**2020 ROADWAY IMPROVEMENT PROJECT
PLAISTED CIRCLE, EYSSI DRIVE
SALEM, NH****ADDENDUM No. 1****January 9, 2020**

2020 ROADWAY IMP PROJ
PLAISTED CIRCLE

ADDENDUM #1

DATE: 01/20	JOB NO. —
DWG. SK1	SCALE: N.T.S.

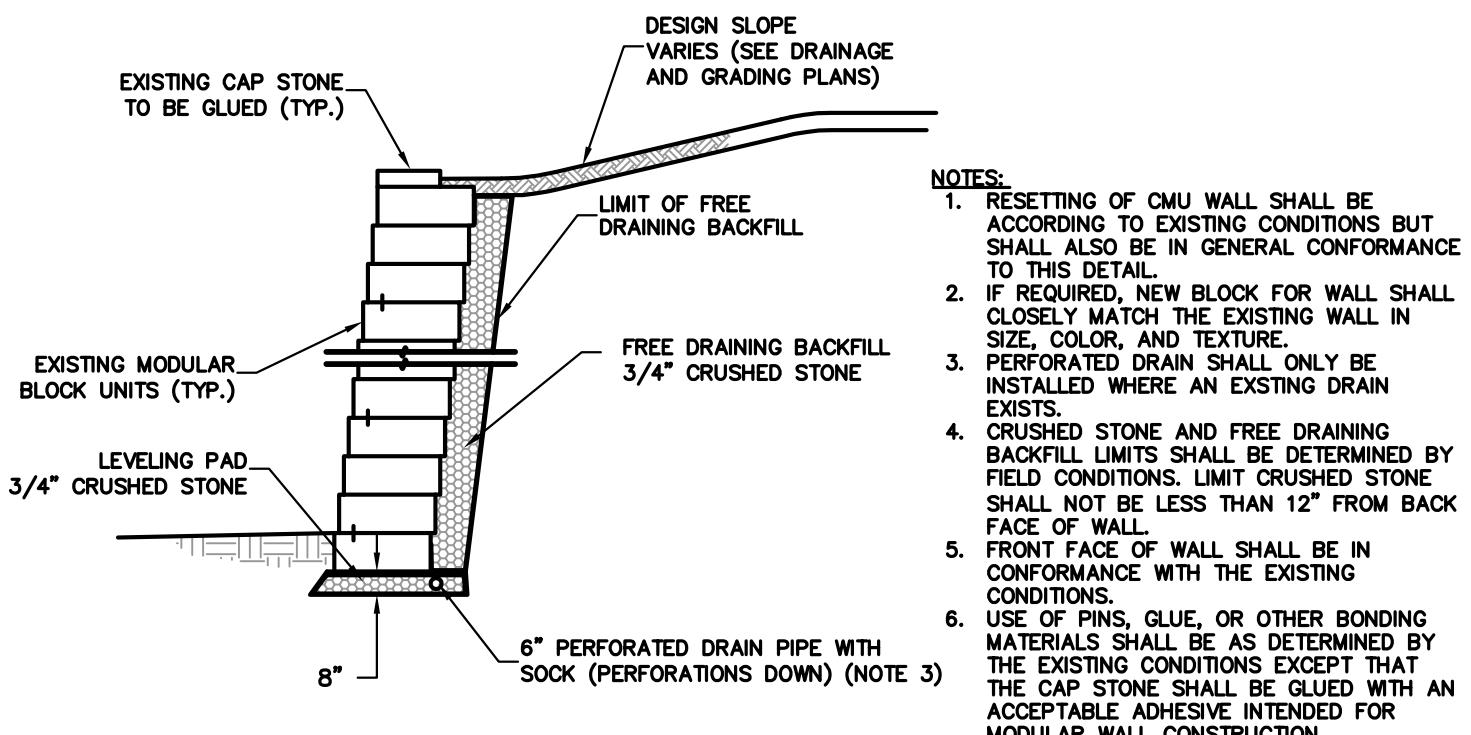
4. **Insert** the attached sketch plan SK1 – Addendum #1 for Reset CMU or Field Stone Ret. Wall in the CONTRACT DOCUMENTS AND SPECIFICATIONS.

Details for Reset CMU and Field Stone Ret. Wall were inadvertently omitted from the Contract Drawings.

Resetting/New Fieldstone Retaining Wall

Resetting CMU Retaining Wall
